**V2500-A5 PROPULSION SYSTEM SERVICE BULLETIN**

This document transmits the Initial Issue of Service Bulletin EV2500-73-0182

**V2500-ENG-73-0182**  
Transmittal - Page 1 of 2

ENGINE FUEL AND CONTROL – FUEL METERING UNIT – INTRODUCTION OF A WOODWARD AIRCRAFT  
ENGINE SYSTEMS (WAES) FMU WITH REVISED TAMPER PROOFING FOR THE FUEL METERING VALVE  
(FMV) MAX. FUEL FLOW STOP AND THE FMU NAMEPLATE

Family Tree  
Fig.1

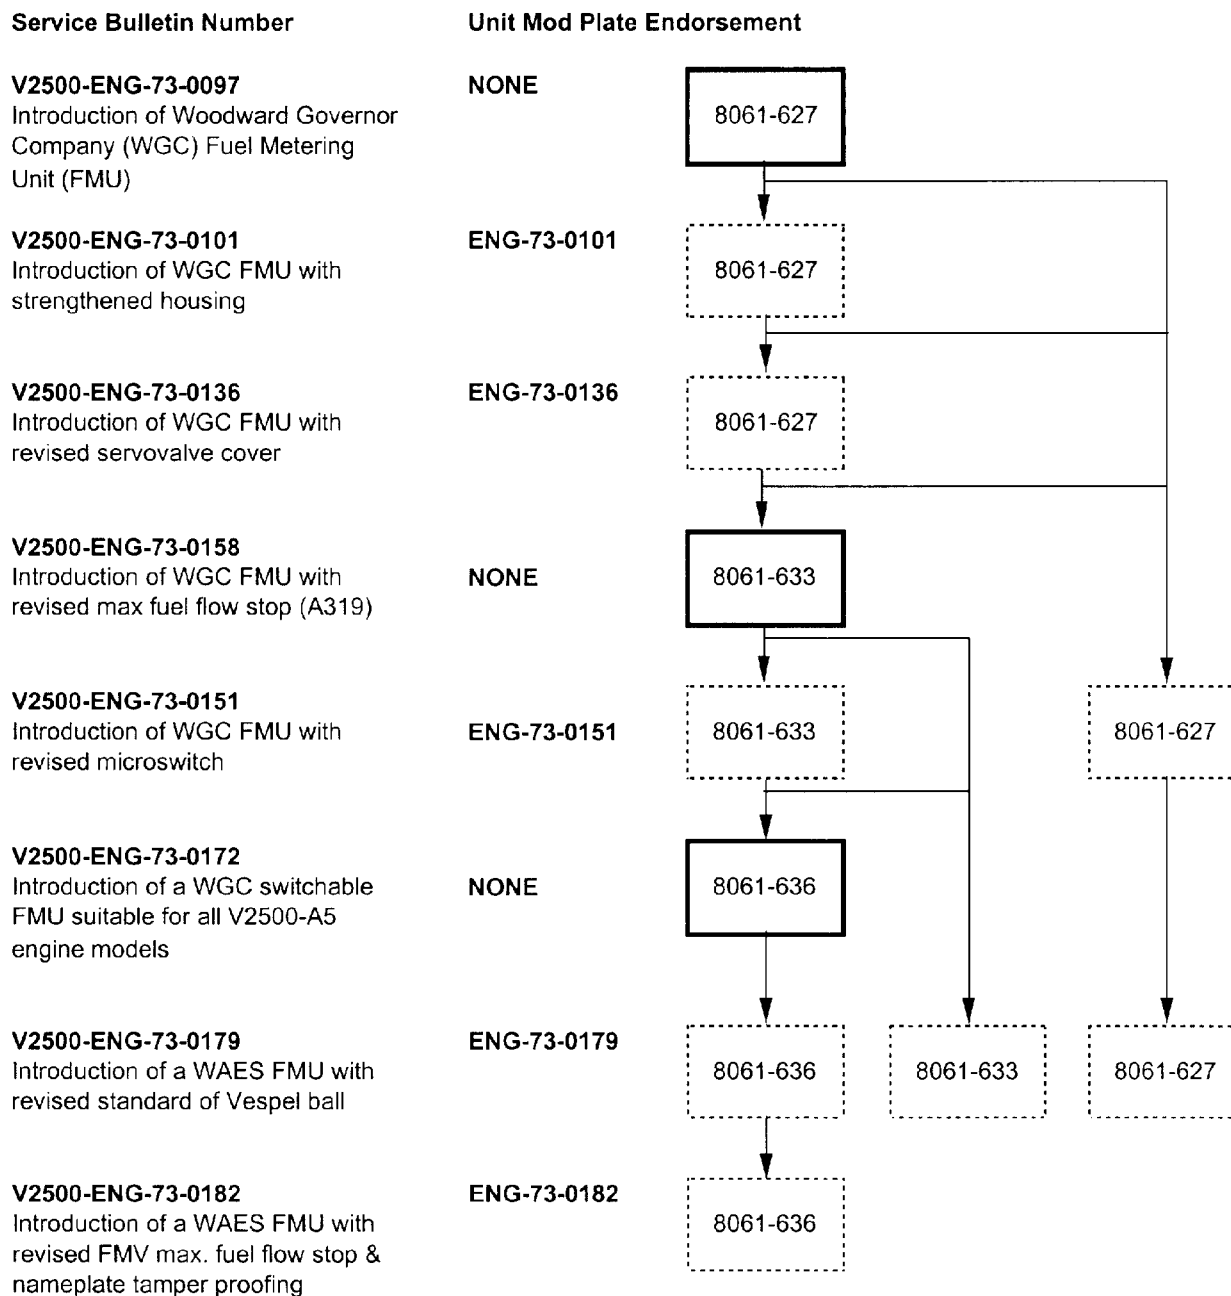
### **V2522-A5 and V2524-A5 FMU Family Tree \***

Family Tree  
Fig.2

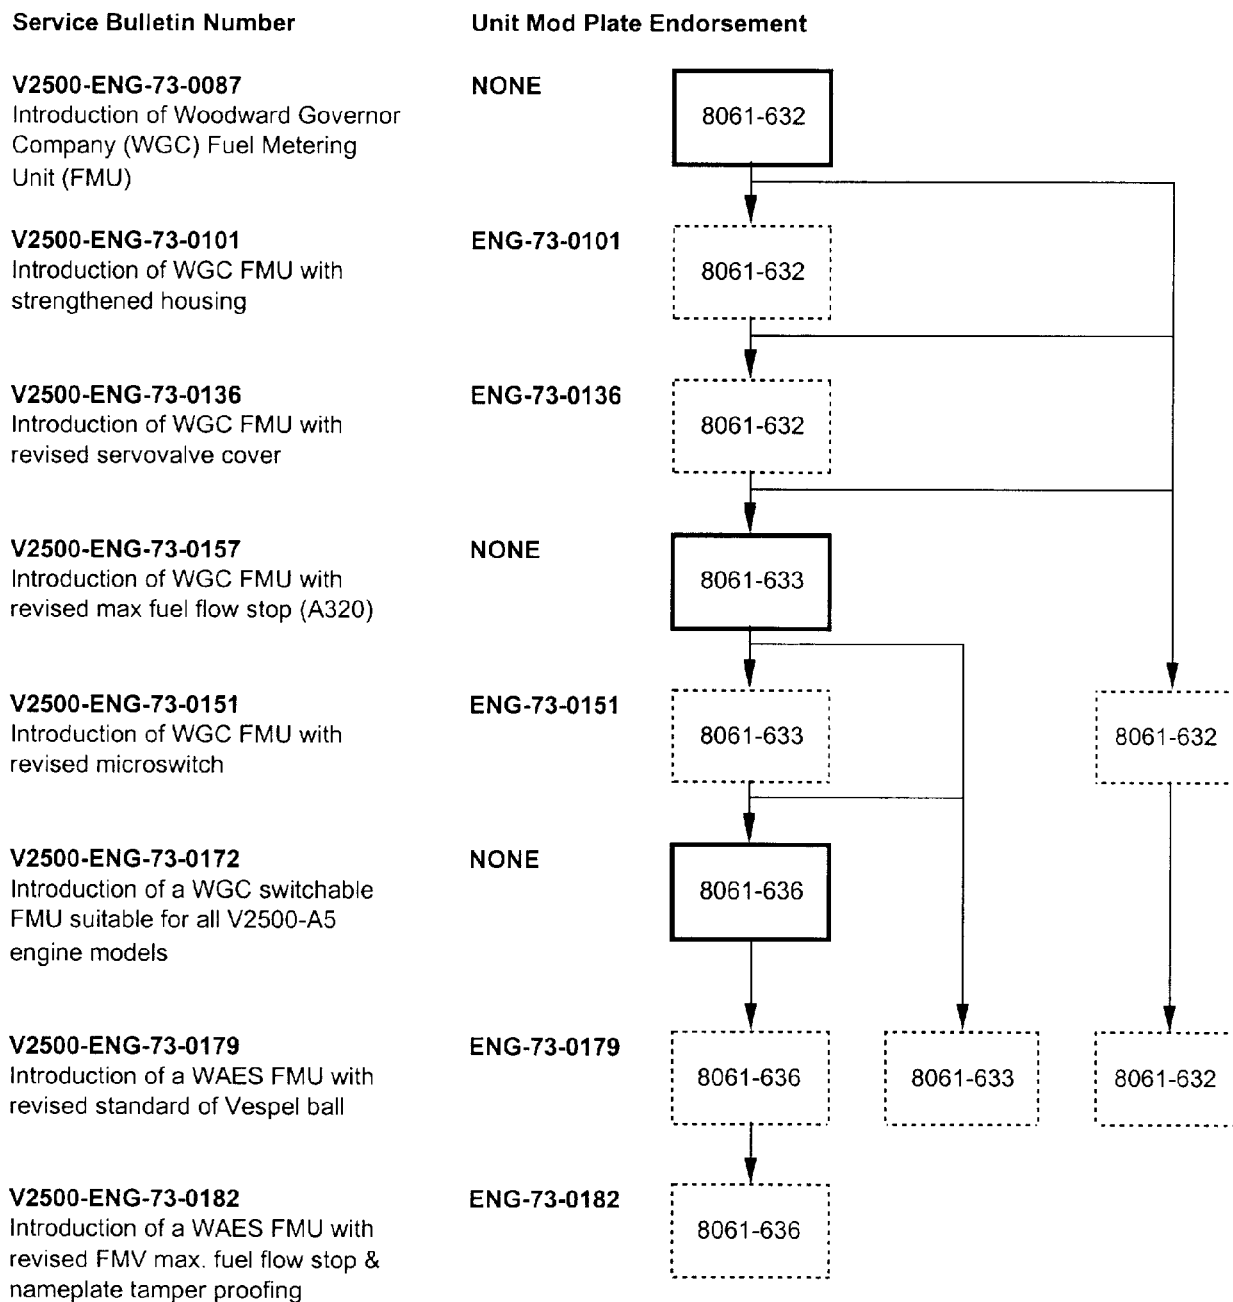
### V2527-A5 and V2527E-A5 FMU Family Tree \*

Family Tree  
Fig.3

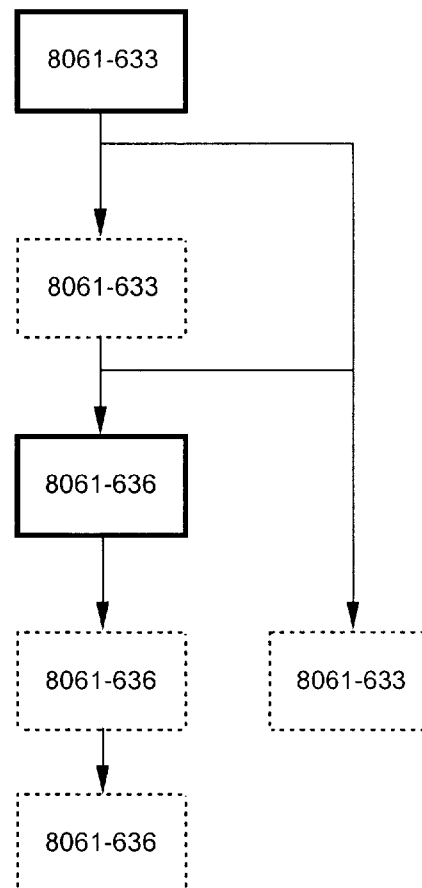
Introduction of a WAES FMU with revised FMV max. fuel flow stop & nameplate tamper proofing

**ENG-73-0182**

Family Tree  
Fig.4

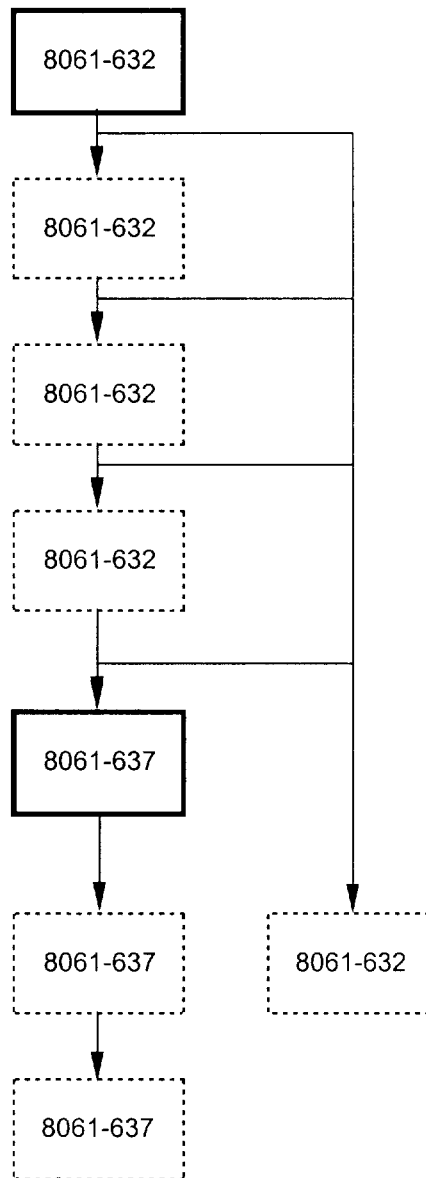
Introduction of a WAES FMU with revised FMV max. fuel flow stop & nameplate tamper proofing

ENG-73-0182
